Response to Reviewers

Manuscript ID: TCCN-TP-26-1155

Hierarchical Load Balancing and Cooperative Beam Hopping for Multi-Satellite Direct-to-Cell LEO Networks

Revised manuscript Fig. 9 (reproduced). ISA sensitivity to the cooling coefficient and iterations per temperature. Curves show mean load variance for the two demand-imbalance groups; bars show mean runtime.

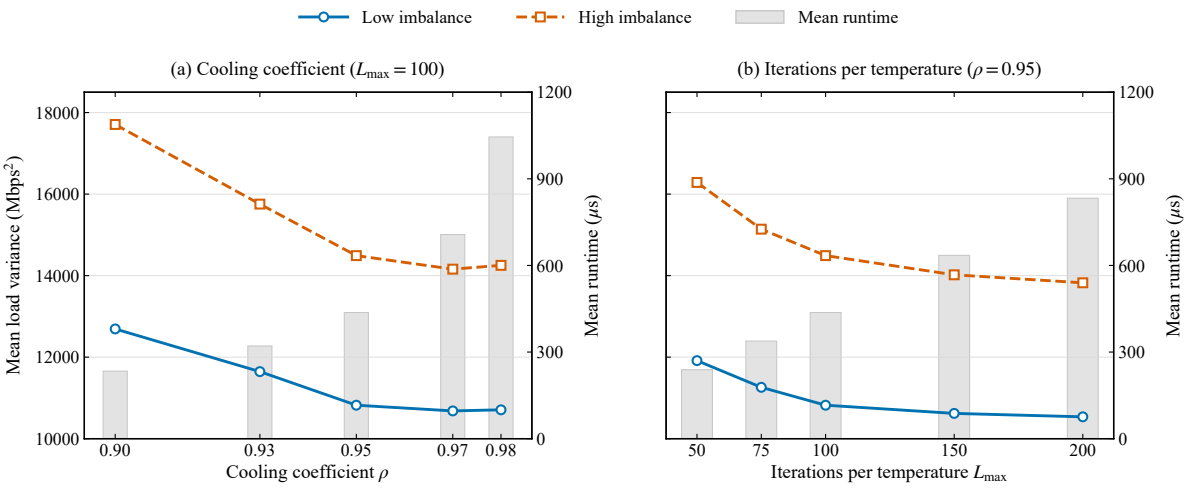
> The annealing parameters directly govern exploration depth and solution quality, yet the fixed cooling schedule may overstay at high temperatures or under-refine locally depending on the energy landscape, and parameter sensitivity across different traffic distributions remains unquantified despite its cascading impact on subsequent scheduling stages.

Thank you for this suggestion. We have added an ISA parameter sensitivity study in Section VI-B-5, with results presented in the new Fig. 9. The study examines how the cooling coefficient and the number of iterations per temperature affect load balancing and runtime under different traffic-demand distributions.

The default setting $(\rho, L_{\max}) = (0.95, 100)$ yields a mean load variance of 12656 $(\text{Mbps})^2$ and a mean runtime of 437 μs. Increasing ρ to 0.97 reduces variance by 1.86% but increases runtime by 61.78%. Increasing $L_{\max}$ to 200 reduces variance by 3.76% but increases runtime by 90.62%.

These results show that the default setting $(\rho, L_{\max}) = (0.95, 100)$ provides a good balance between load-balancing performance and runtime under the tested traffic conditions. We therefore retain this setting.

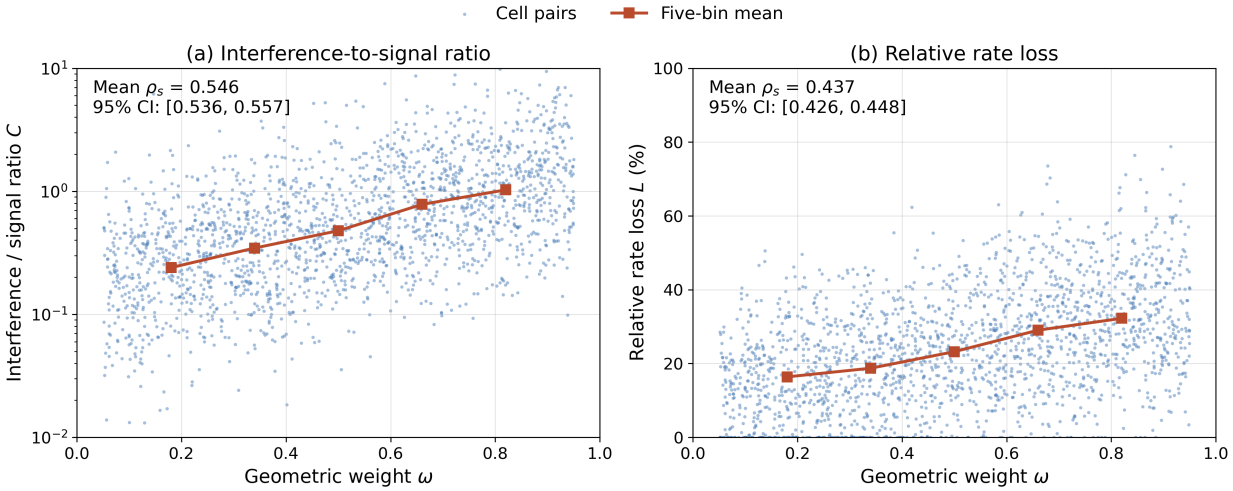
> Distance-derived interference weights in the graph attention mechanism may misrepresent actual coupling because beam sidelobe patterns and frequency overlaps determine interference beyond spatial proximity, yet this paper validates neither the correlation between static weights and achieved rate variations nor whether the learned features track physical interference dynamics under agile beam pointing.

We have added a controlled pairwise diagnostic in Section VI-B, using the antenna and channel models over 200 independent scenarios with 300 users each. The reference beam power is $P_{\text{tot}}/K_{\max}$, and the reference bandwidth is 0.5 MHz. For each direction of a cell pair, victim-cell rates are calculated with and without the specified interfering-beam contribution, keeping the desired signal, channel realization, and noise fixed. The interference-to-signal ratio and relative rate loss are then averaged over the two directions.

The mean scenario-wise Spearman correlations with the distance weight are 0.546 (95% scenario-level bootstrap CI: [0.536, 0.557]) for the interference-to-signal ratio and 0.437 (95% CI: [0.426, 0.448]) for relative rate loss. We have added Fig. R1-4 to this response to present the diagnostic results.

Overall, the physical diagnostic supports the relevance of the distance prior to physical interference effects, and the ablation supports the scheduling benefit of the coverage priors. These results support the usefulness of the proposed geometric and coverage priors for scheduling under the tested conditions.

Revised manuscript Fig. 2 (reproduced). Updated MAPPO framework, including coverage-prior attention, Gaussian samples before Softmax, and sampled-action information stored for PPO.

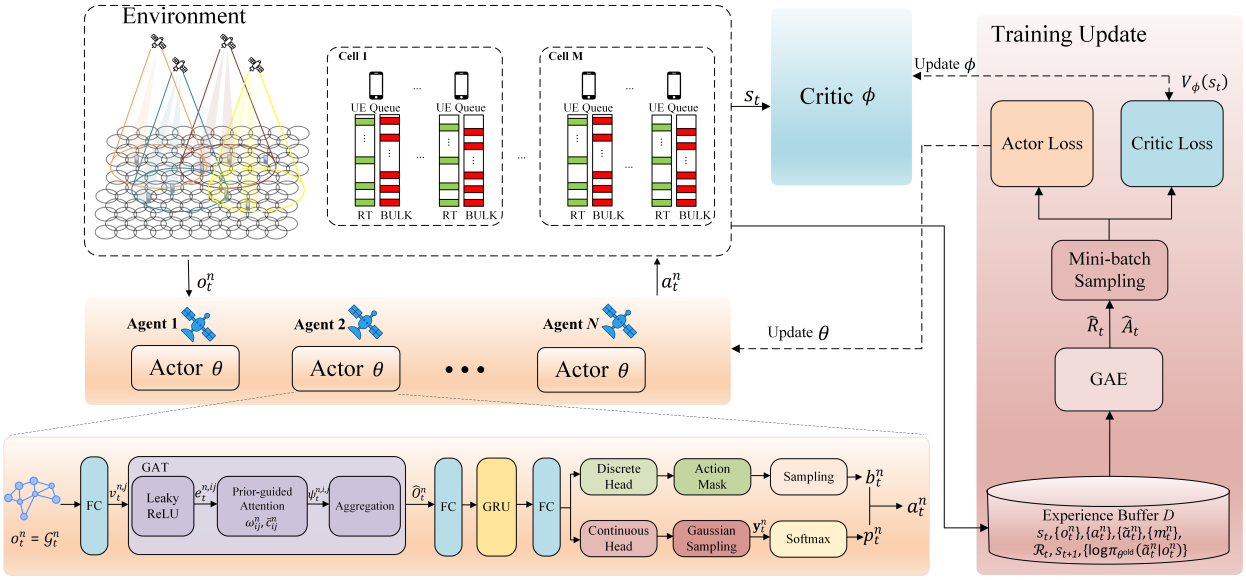
> The hybrid-action probability model is insufficiently explained. The Gaussian-to-Softmax power transformation and sequential beam selection require a clear definition of the action log-probability used in PPO.

Thank you for pointing out that the hybrid-action probability calculation was insufficiently explained. We have clarified the sampled action, the executed action, and the log-probability used by PPO in Section V-B, with corresponding updates to Algorithm 2 and Fig. 2.

During training, actions are sampled as described above. During testing, masked Top-K selects the cells, and Softmax applied to their Gaussian means gives deterministic power allocation ratios. These descriptions specify how actions are sampled, evaluated by PPO, and executed.

Revised manuscript Fig. 8 (reproduced). Ablation results for coverage priors, GAT, GRU, and learned power allocation. Error bars show pointwise 95% confidence intervals across five independent training-seed means.

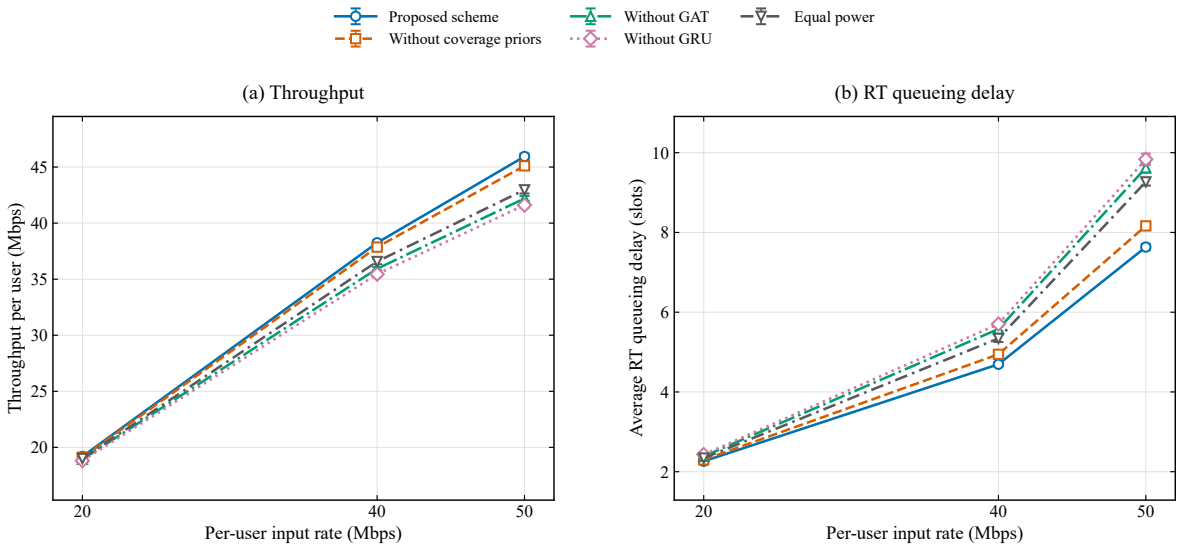
> The simulation study should better isolate the source of performance gains. Additional ablations, such as MAPPO with equal power, without GAT, and without GRU, as well as confidence intervals over multiple random seeds, should be provided.

Thank you for this suggestion. We have added an ablation study in Section VI-B-3, with results presented in the new Fig. 8. The study compares the proposed method with four variants: Without coverage priors, Without GAT, Without GRU, and Equal power. In the variant without coverage priors, the actor's coverage-degree feature is set to zero and the common-visibility attention term is removed, while the distance prior is retained. This experiment assesses the joint contribution of the two coverage priors.

At a per-user input rate of 50 Mbps, the full model achieves 45.94 Mbps per user (95% CI: [45.68, 46.20]) and 7.634 slots of RT queueing delay (95% CI: [7.556, 7.712]). Compared with the variant without coverage priors, throughput is 1.85% higher and RT delay is 6.49% lower. Compared with equal power, throughput is 6.92% higher and RT delay is 17.63% lower. Removing GAT or GRU causes larger degradation at this load than jointly removing the coverage priors.

Revised manuscript Fig. 7 (reproduced). Throughput per user and average RT queueing delay for different beam hopping schemes. Error bars indicate pointwise 95% confidence intervals of the means across 200 test cases.

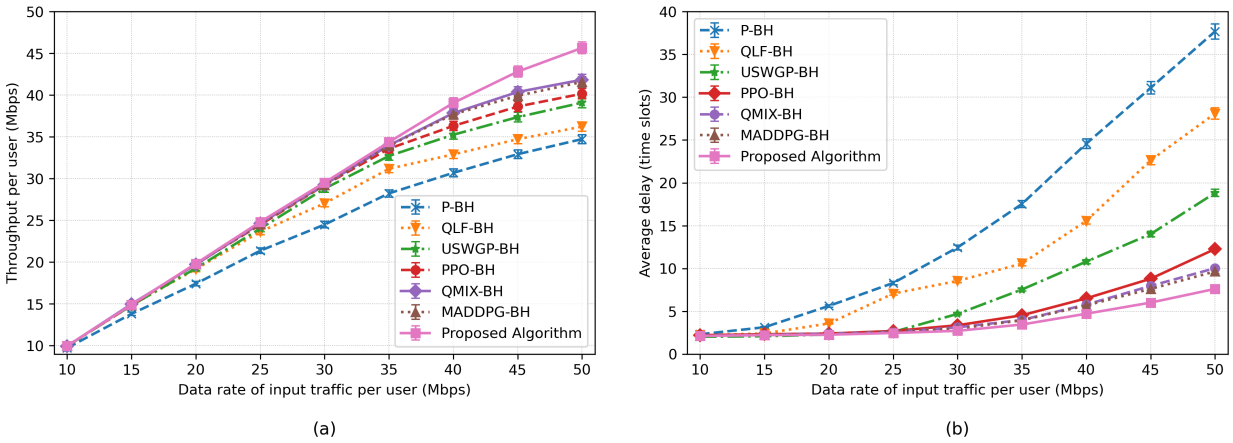
> In Figs. 6 and 7 on pages 11–12, the reported performance is averaged over 200 test instances, but the variability of the simulation results is not shown. It would be helpful to provide error bars or briefly report the standard deviation/confidence interval to further demonstrate the robustness of the performance gains.

Thank you for this suggestion. We have added error bars to the throughput and RT queueing-delay panels in Figs. 6 and 7. At each input rate, the error bars show pointwise 95% confidence intervals of the means across 200 test cases. The figure captions and Section VI-B define these intervals, and the reported $\pm$ values give their half-widths.
